March 18, 2019

**Attn: Docket ID No. EPA-HQ-OAR-2013-0495**

**RE: Comments of Environmental Defense Fund on EPA's Proposed Review of Standards of Performance for Greenhouse Gas Emissions From New, Modified, and Reconstructed Stationary Sources: Electric Utility Generating Units, 83 Fed. Reg. 65,424 (Dec. 20, 2018).**

Figure 1: Impact of Changing T&S Costs and Capacity Factor on LCOE<sup>194</sup>

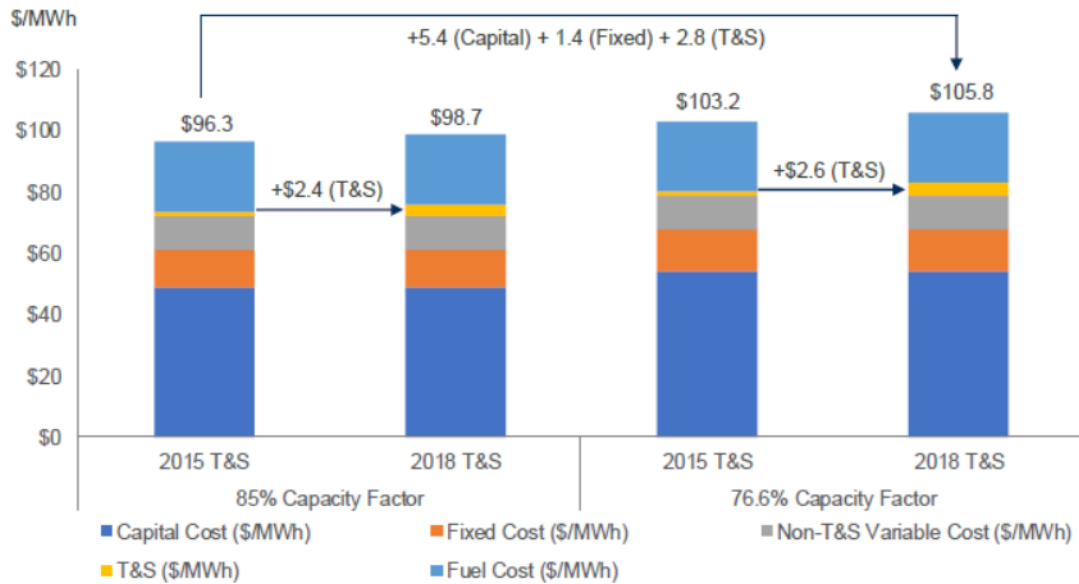
In addition to the adjustments to T&S costs, EPA also uses a lower capacity factor of 76.6% compared to its original 85% capacity factor. Without changing the T&S assumption, the capacity factor change increases the LCOE by \$6.9/MWh or 7.2%. As shown in Figure 1, the combination of the T&S and the capacity factor change have the effect of increasing the final LCOE for new coal-fired EGUs with 16% CCS by \$9.5/MWh or 9.9%. Of the \$9.5/MWh increase, about 75% is the result of the change in capacity factor.

Figure 2: Estimated T&S Costs (\$ per metric ton)<sup>198</sup>

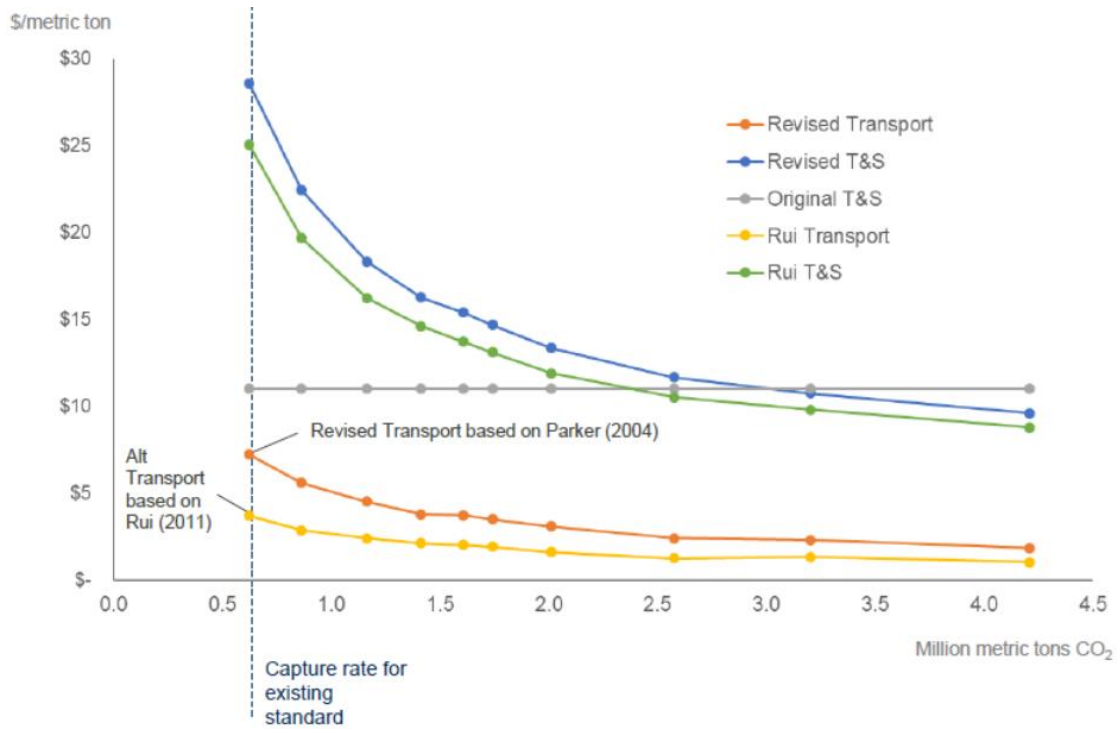
When estimating transportation costs, EPA relies on costs drawn from a 2004 study by Parker.<sup>195</sup> Using the NETL transport model, EPA estimates a transportation cost of roughly \$7 per metric ton at a 16% capture rate. However, as shown in Figure 2, using more recent 2011 costs by Rui as input in the NETL transport model yields lower transportation costs—less than \$5 per metric ton at a 16% capture rate.<sup>196</sup> Rui's estimates are based on more recent cost data and therefore better reflect the pipeline infrastructure for CCS capture.<sup>197</sup>

Figure 3: Estimated T&S Costs (\$/MWh)<sup>199</sup>

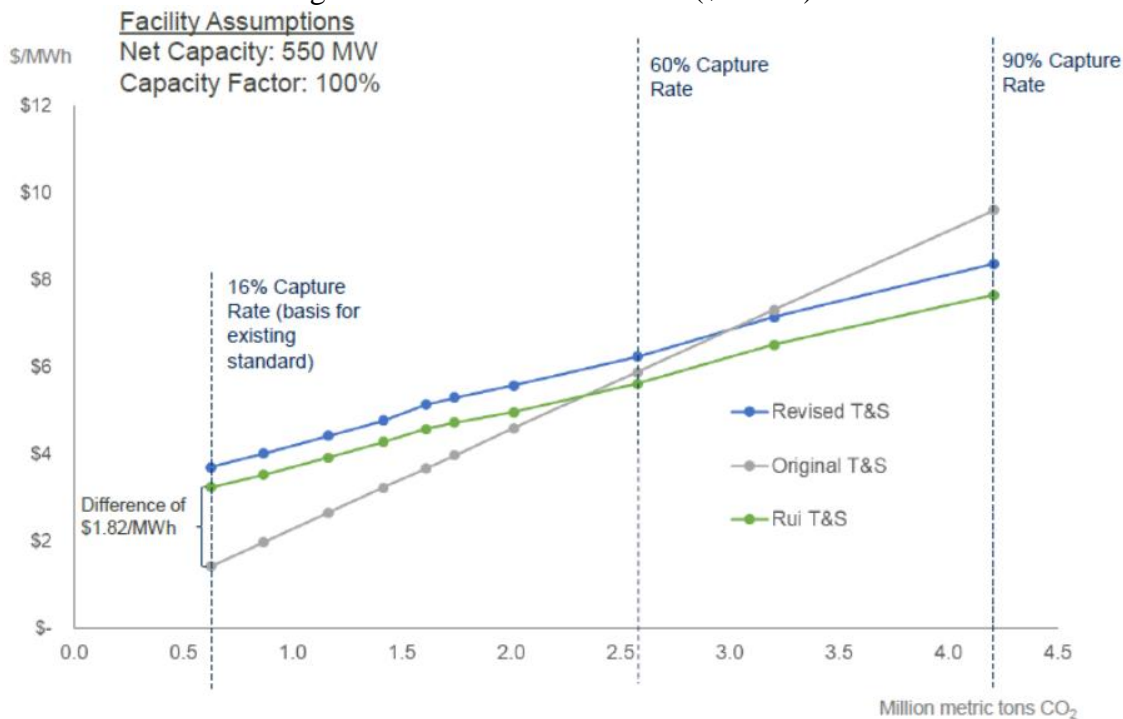
As shown in Figure 3, this translates to a \$0.45/MWh reduction in the costs reported in the Proposal for a new coal-fired EGU with 16% capture rate.

Figure 4: MISO Indiana Supply Curve and Variable Costs of EGUs<sup>213</sup>

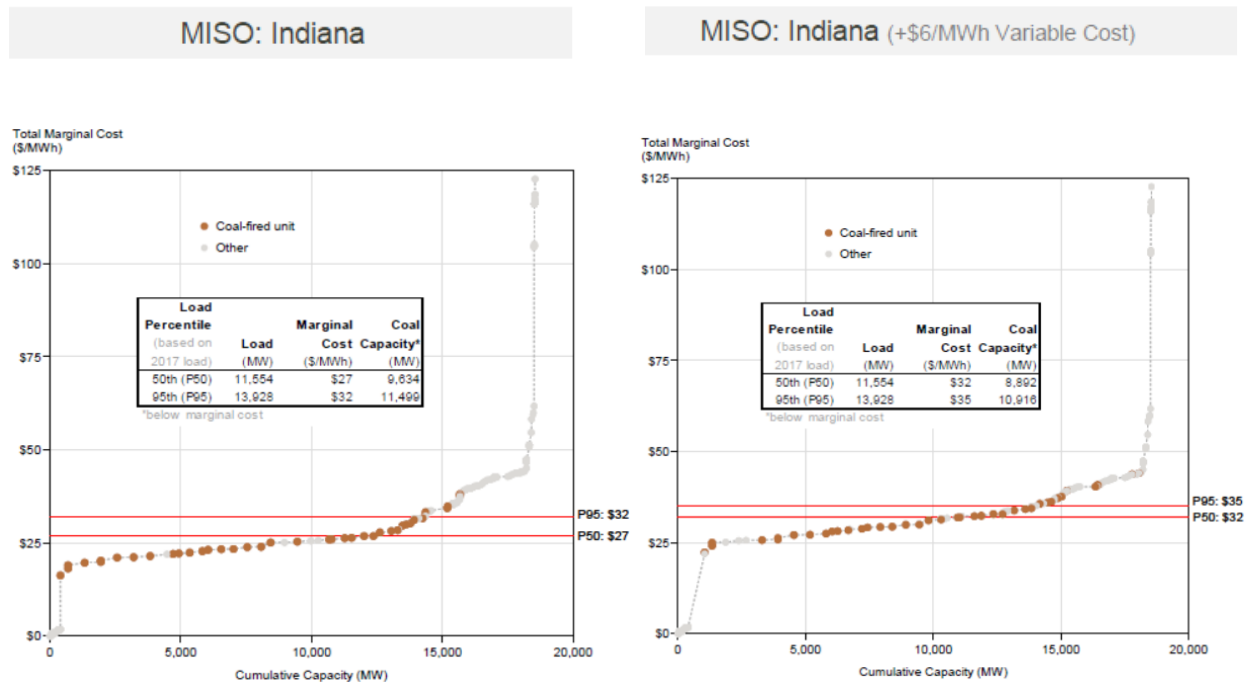
Figure 4 shows the regional electricity supply curve in the Indiana transmission area within the Midcontinent Independent System Operator (MISO) region before and after applying a \$6/MWh increase to the marginal costs of all coal-fired EGUs—equivalent to EPA’s assessment of the variable cost increase due to partial CCS.<sup>214</sup> As shown, well over 90% of the area’s in-the-money coal-fired capacity continue to remain so after the addition of a \$6/MWh increment to their variable costs.

Figure 5: MISO Minnesota-North Dakota Supply Curve and Variable Costs of EGUs<sup>215</sup>

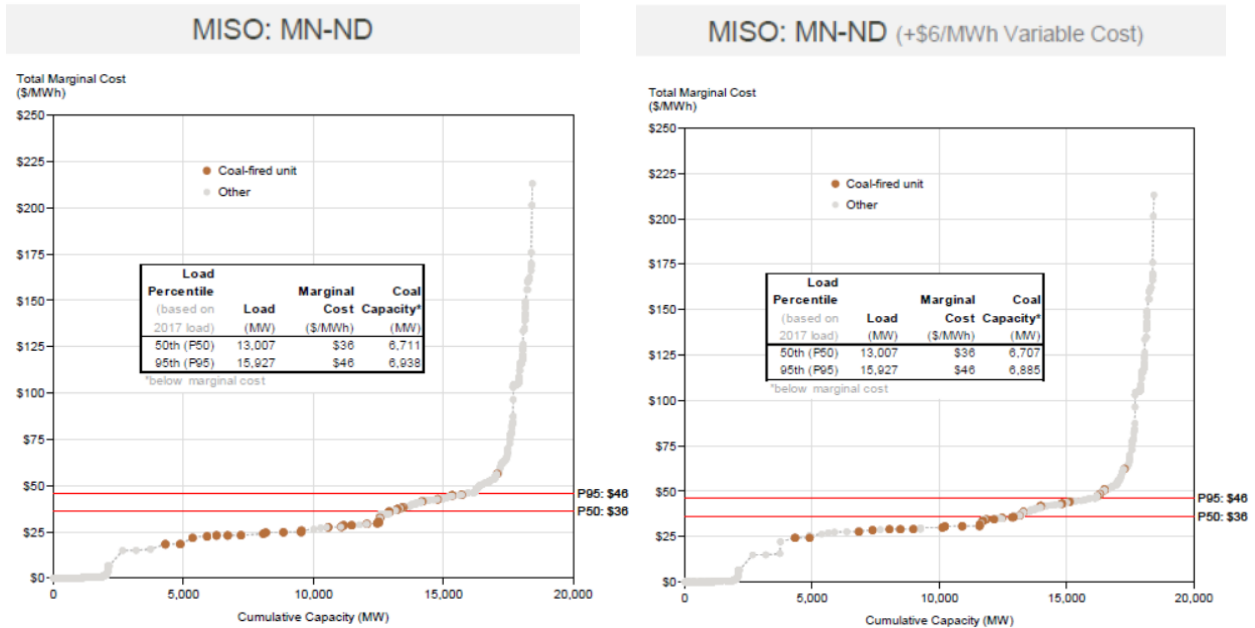
Figure 5 shows the regional electricity supply curve in the Minnesota-North Dakota transmission area in MISO before and after applying a \$6/MWh increase to the marginal costs of all coal-fired EGUs. As shown, nearly 100% of the area’s in-the-money coal-fired capacity continue to remain so after the addition of a \$6/MWh increment to their variable costs. In other words, for both the Indiana and Minnesota-North Dakota transmission areas in MISO, the increase in variable costs due to partial CCS is not expected to materially affect coal plant utilization or capacity factor.

Figure 6: Illustrative Effect of Binning and Averaging on R<sup>2</sup> Values

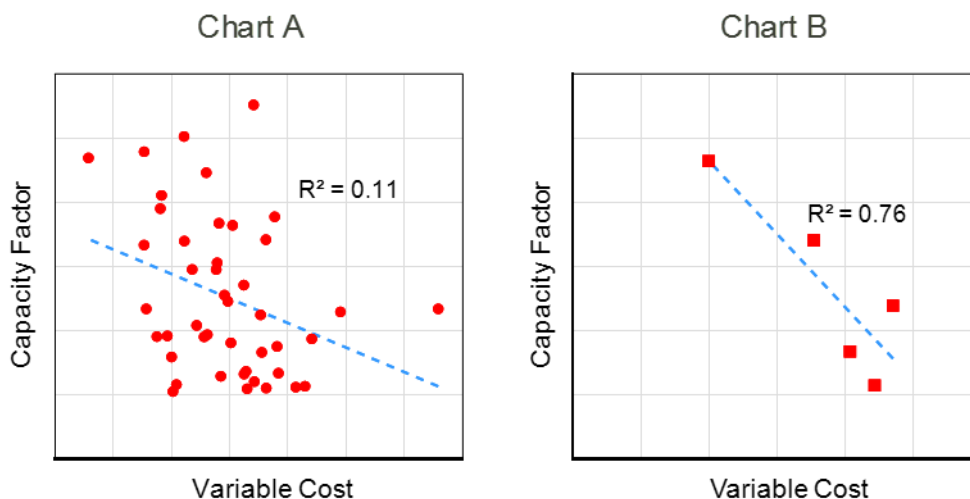
To illustrate how binning and averaging can artificially and significantly inflate R-squared values, consider the charts in Figure 6. Chart A is a scatter plot of about 40 randomly selected existing coal-fired power plants according to their variable costs and capacity factors in 2017. Running a simple regression analysis with these two variables suggests a relatively weak correlation of 0.11. However, grouping the same raw data for the 40 EGUs into five separate bins and plotting the average variable costs and capacity factors of each bin as a sample data point produces a much tighter apparent relationship with an R-squared value of 0.76 (Chart B). In other words, binning creates the impression of a strong relationship even when the underlying data shows no such relationship. EPA has thus not provided evidence of a relationship between capacity factors and variable costs, undercutting the notion that increased variable costs would be likely to result in reduced capacity factors such that plants could not recover those costs.

Figure 7: Annual CO<sub>2</sub> Emission Rates of USC and SC Coal EGUs<sup>545</sup>

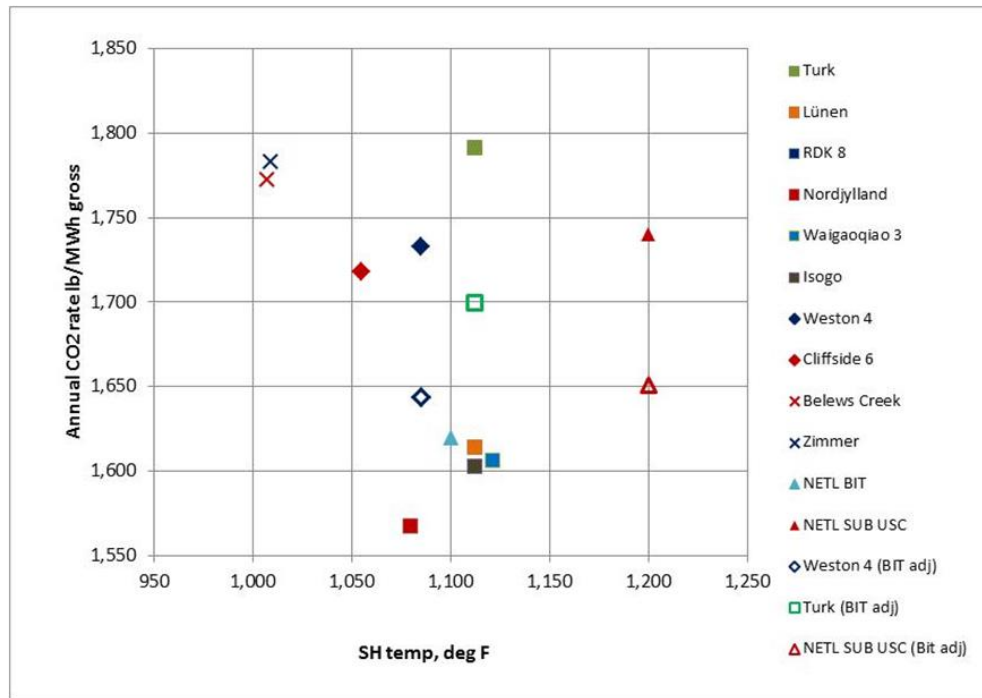
EPA’s proposed standard for large coal EGUs is 1,900 lb/MWh-gross. According to EPA, the proposed standard is based on the use of ultrasupercritical (USC) or supercritical (SC) steam generation technology.<sup>542</sup> Yet according to Andover, and as shown in Figure 7, an assessment of USC and SC coal units in both the United States and abroad demonstrates that emission rates associated with these units are well below EPA’s proposed standard.<sup>543</sup> In fact, EPA’s own analysis when normalizing the Weston 4 coal unit for purposes of proposing the new standard shows that an advanced ultra-supercritical unit with bituminous coal and wet cooling can achieve a 1,550 lb/MWh-gross rate with 99% confidence.<sup>544</sup>

Figure 9: Utilization of Fossil-Fired Capacity (Reference Case)<sup>692</sup>

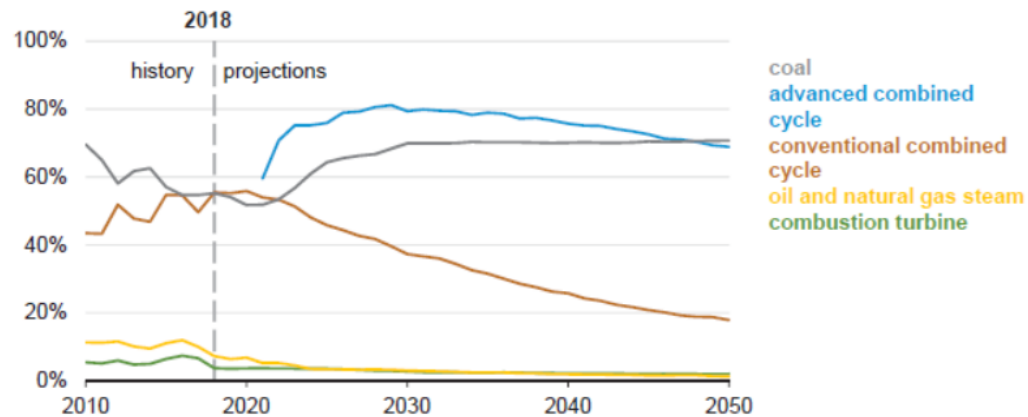
We find no basis for EPA to change its treatment of non-baseload combustion turbines. As evidenced by EIA's recent 2019 Annual Energy Outlook and shown in Figure 9, higher penetration of wind and solar resources and low natural gas prices are projected to result in higher utilization of new advanced natural gas combined cycle units.<sup>690</sup> New advanced natural gas combined cycle units are more flexible and have higher efficiencies and lower costs compared to other fossil-fired generating technologies including conventional natural gas combined cycle and simple cycle combustion turbines. According to EIA, new advanced combined cycle natural gas units are projected to have the highest utilization of all fossil-fired generating technologies while utilization of lower efficiency conventional combined cycle units

**Figure 1. Normal Distribution Curve**

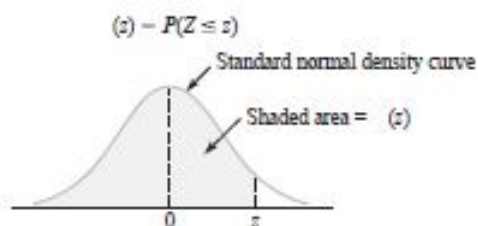
In determining the 99% confidence level emissions rate, EPA took the average emission rate and added the standard deviation times 2.57.<sup>5</sup> This is, in fact, incorrect. In a normal density curve, shown in Figure 1, to be certain that the emission rate is below the limit 99% of the time, the multiple of the standard deviation should be selected so as to ensure that the shaded portion of the figure equals 0.99. That occurs when  $z = 2.33$ . When  $z=2.57$  the shaded portion of the curve is equal to 0.995. We are only concerned about emissions *exceeding* the NSPS limit, not if the emissions are too low. So,  $z=2.33$  is the correct value of  $z$  to use if it was EPA's intent to

determine an NSPS limit at a 99% confidence level. Correcting this error to reflect a 99% confidence level will have the effect of lowering each of the emission rates shown in Tables 1 through 3 somewhat.
